# Flex PLI

## Drawing Review

Issue 4 (updated by Patrick Gay) – 29/05/2013

# 133-5530

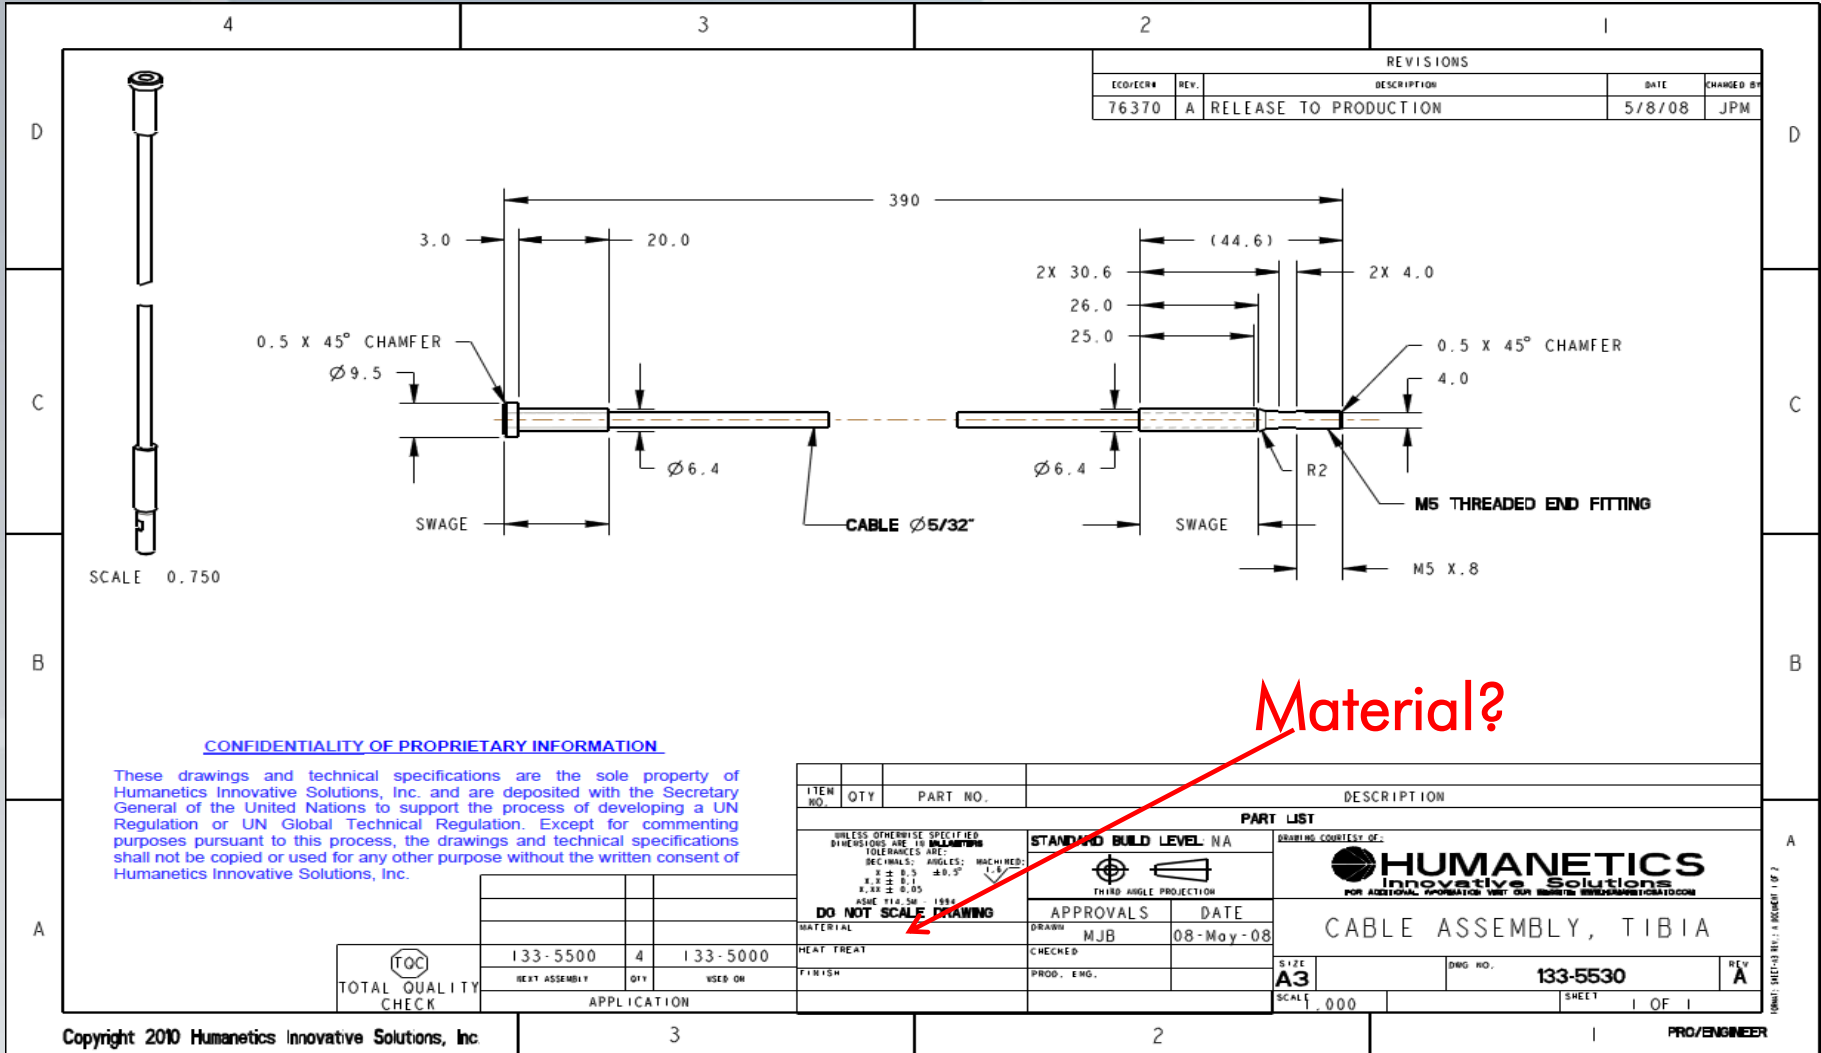
Material?

# 133-5100

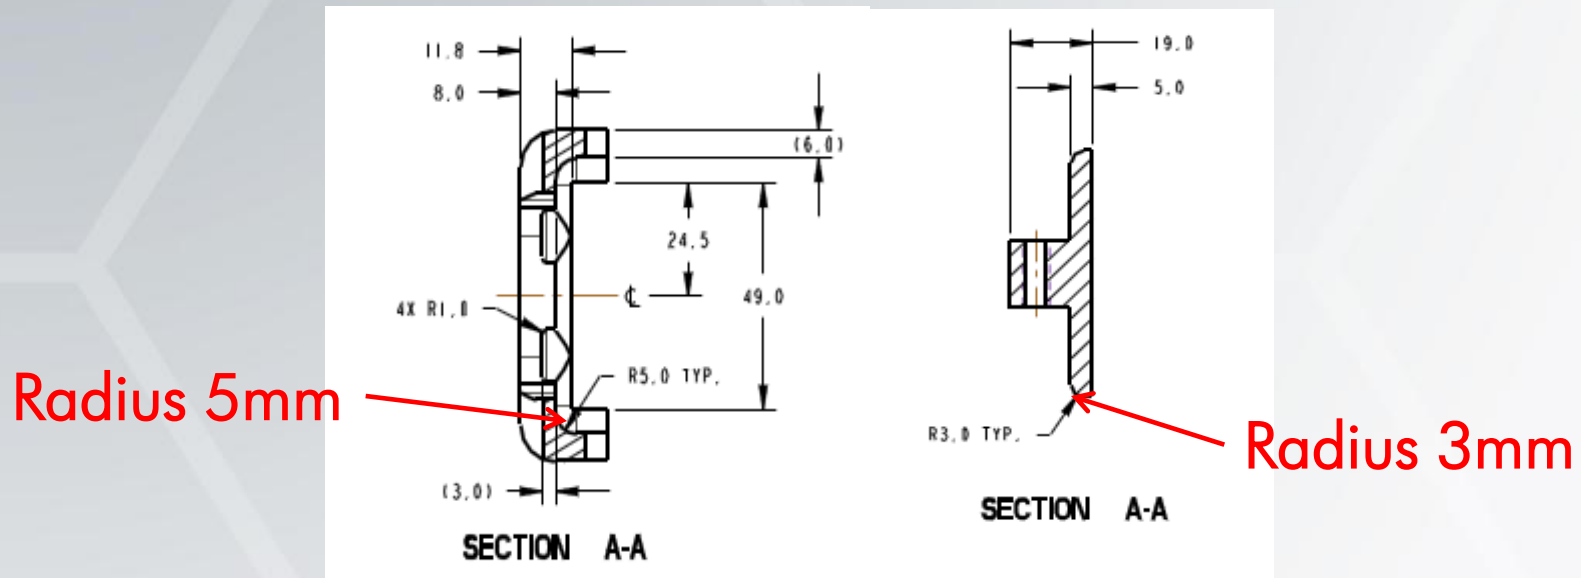
Parts 28 (133-5516) and 17 (133-5102) cannot fit properly.

Figure 43 . Showing drawing of Micro Dau part numbers

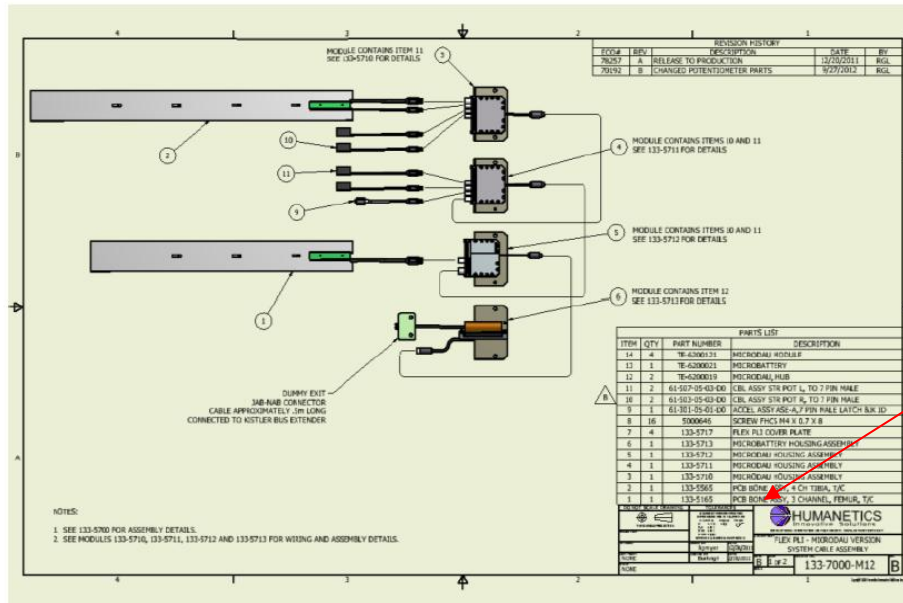
Should the reference of this drawing to be deleted (specific to one type of instrumentation?) or should be included in drawing package?

Drawing incorporated in user manual but not appearing in drawing package (user manual p40 of 99).
